Weston and Haringey Parks Residents' Association

21st August 2017

RE: PROPOSED DEVELOPMENT, HORNSEY TOWN HALL, CROUCH END
Reference: HGY/2017/2220

Site area for Density calculation purposes:

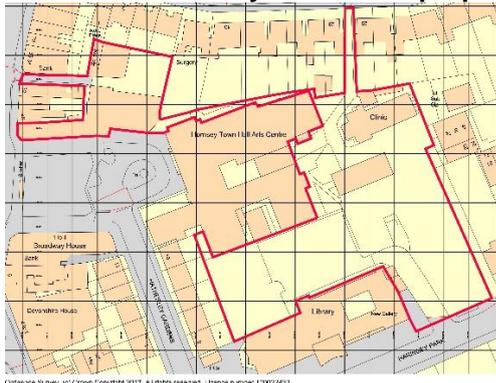
The developers have included the Town Hall 'square' as developable site area for calculation of density, inflating the available site area and decreasing the actual density. The Town Hall 'square' should not be included in the overall site area for calculation purposes; it is a public space, which by the Council's own criteria is dedicated to Community, was never intended to be built upon and whose inclusion in the site area calculation serves only to dilute the scheme's real density. Similarly, the inclusion of the Town Hall itself, when this area is not part of the application for residential construction, should not be included in the calculations.

The diagram below shows the site area that *should* be used for calculation of density – removing the Town Hall Square and Town Hall and Hotel (or aparthotel). The relevant area is outlined in red, (although we are concerned by the inclusion of Rose Place in the Developer's proposals and calculations)

Actual site area for density calculations: **0.78 hectare**

Residential units: **146**

Density = 187 units per hectare or 409 habitable rooms per hectare

This is *above* the range indicated in the London Plan Policy.

3D MODELLING TO SHOW RELATIVE SCALE AND OVERSHADOWING. To the best of our knowledge these are to scale but we wish to see the same interactive model produced by the applicant

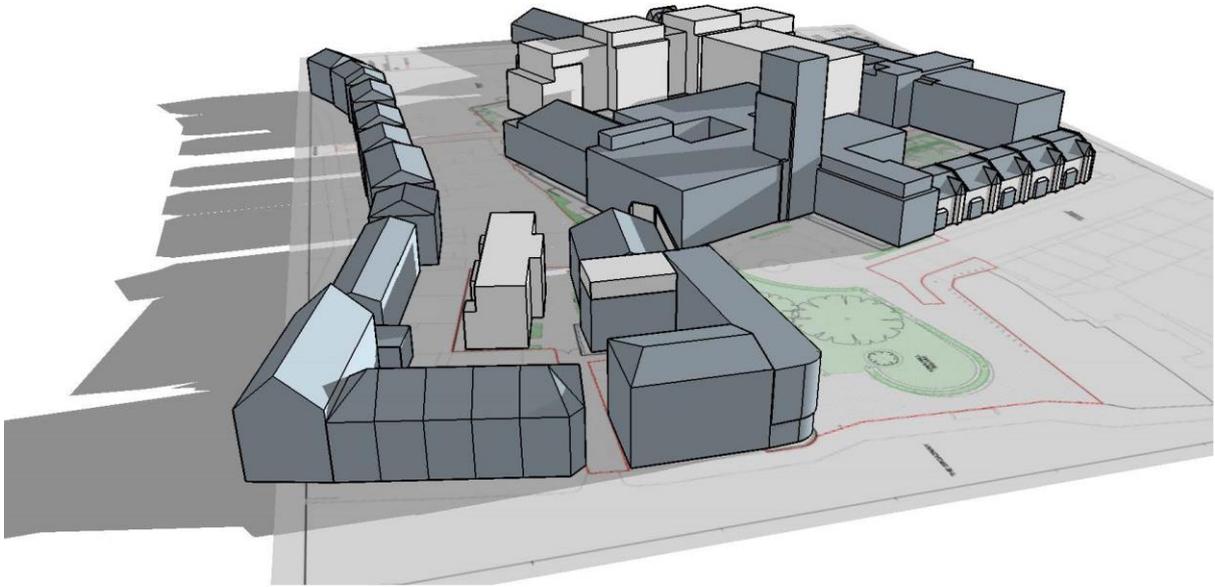
Appendix: we have added our own 3d Modelling below to show the affect of this development on our neighbourhood – both in terms of scale and overshadowing. We would like to see the same interactive model produced by the applicant.

View showing Hatherley Gardens with the new flats looming behind

View on 21st September at 12pm showing overshadowing of Weston Park from new Mews block, and the proximity of one to the other.

View on 21st December at 12pm showing overshadowing of Weston Park from new Mews block and most of new development in shadow.

View on 21st December at 12pm showing overshadowing of Primezone Mews, and most of new development in shadow. As the sun moves round to the west, the whole of Primezone Mews is in shadow.

View on 21st June at 4pm showing overshadowing of Primezone Mews during Summer. As the sun moves round to the west, more of Primezone Mews is in shadow.
